KANSAS GAS AND ELECTRIC COMPANY

Subj: Technical Specifications

The Reference provided the "final draft" of the Wolf Creek Technical Specifications for KG&E review and affirmation.

# TECHNICAL SPECIFICATION CHANGES

FIGURE 6.2-1  
OFFSITE ORGANIZATION

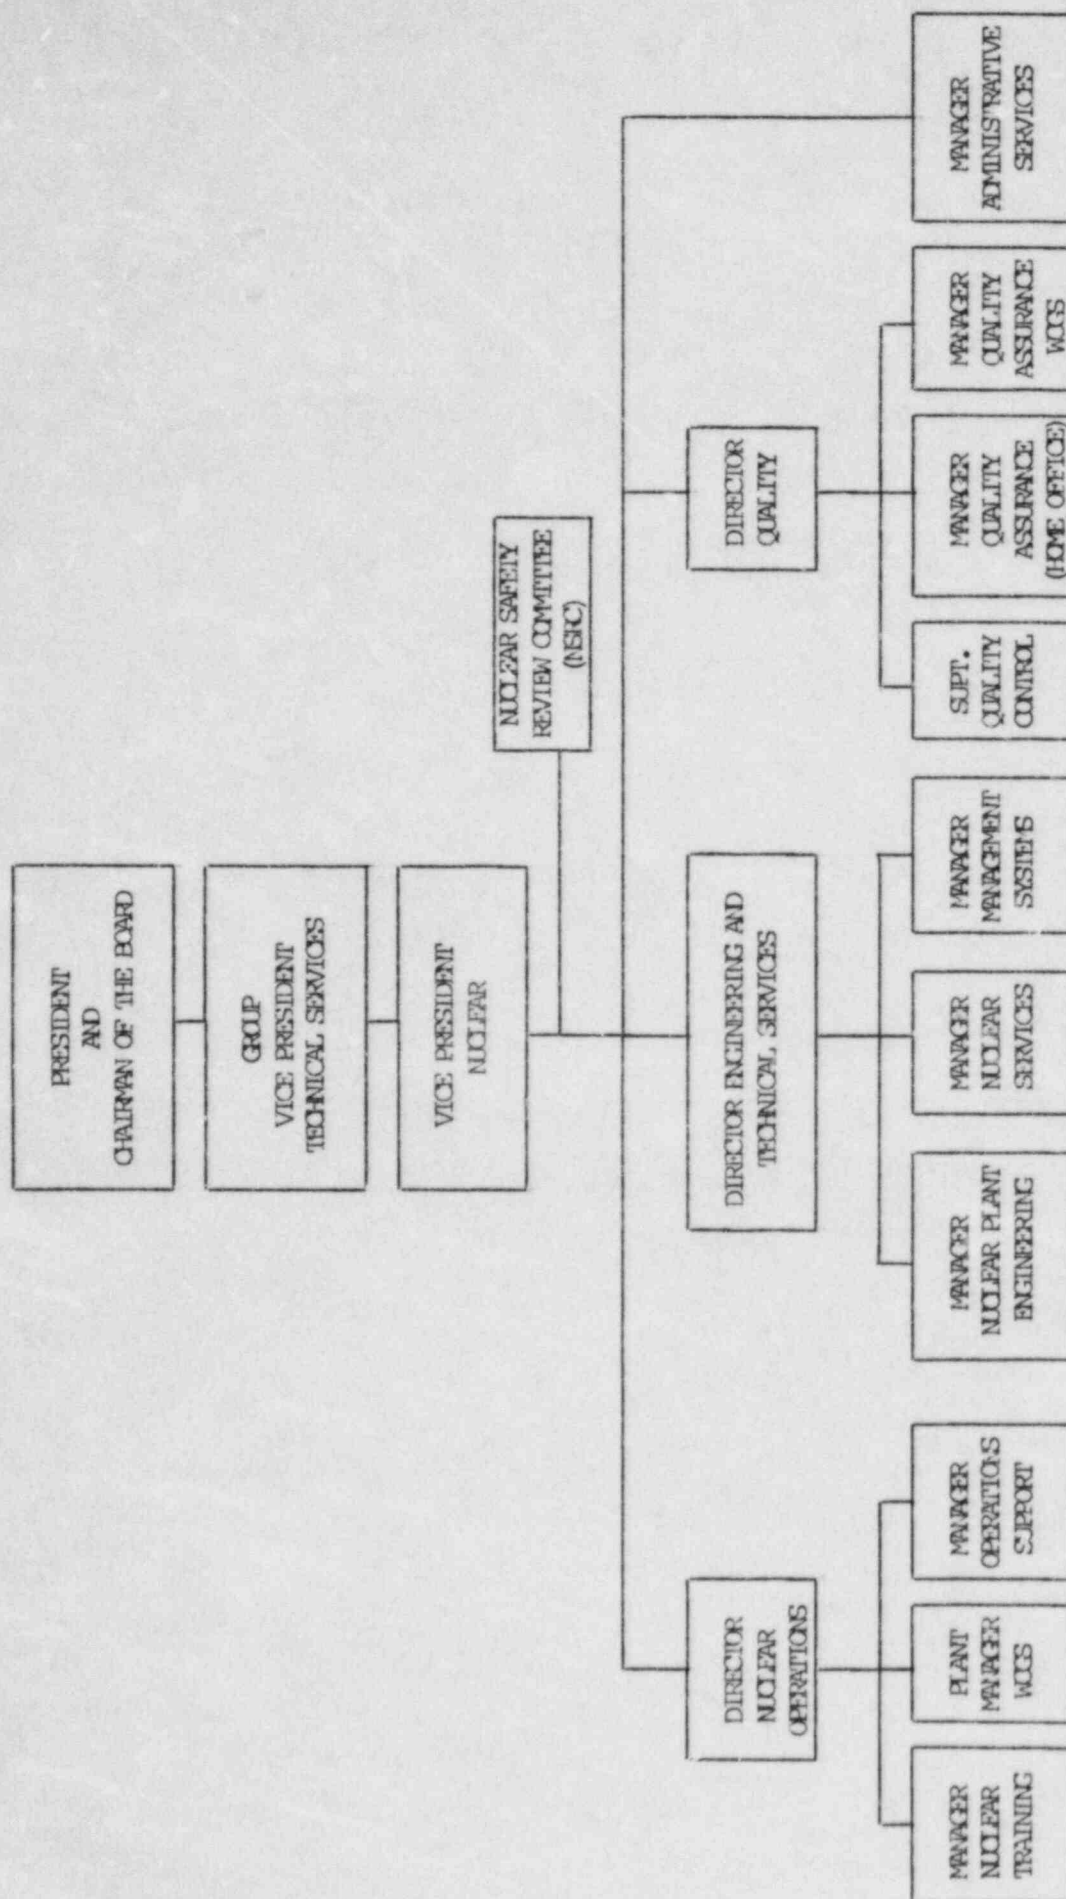
Page	Section	Reason for Change
B 3/4 3-4	3/4.3.3.5	Consistent with design and rest of Tech Spec.
B 3/4 3-5	3/4.3.3.10	Typo.
B 3/4 3-6	3/4.3.3.11	Typo.
B 3/4 4-9	3/4.4.9	Typo.
B 3/4 6-1	3/4.6.1.2	Revised to be consistent with 10CFR50, Appendix J.
B 3/4 6-2	3/4.6.1.6	R.G. 1.35 is not a proposed R.G.
B 3/4 6-3	3/4.6.1.7	Refer to justification for changes to 5.7.
B 3/4 7-6	3/4.7.8	Justification with change in attachment.
B 3/4 8-2	3/4.8.1, 3/4.8.2 & 3/4.8.3	Typo.
B 3/4 11-3	3/4 11.2.1	Typos.
5-2	Fig. 5.1-1	Clarification of Figure.
5-9	Table 5.7-1	Typos.
6-3	Fig. 6.2-1	Update organization chart.
6-4	Fig. 6.2-2	Update organization chart.
6-23	6.12.2	Clarification.
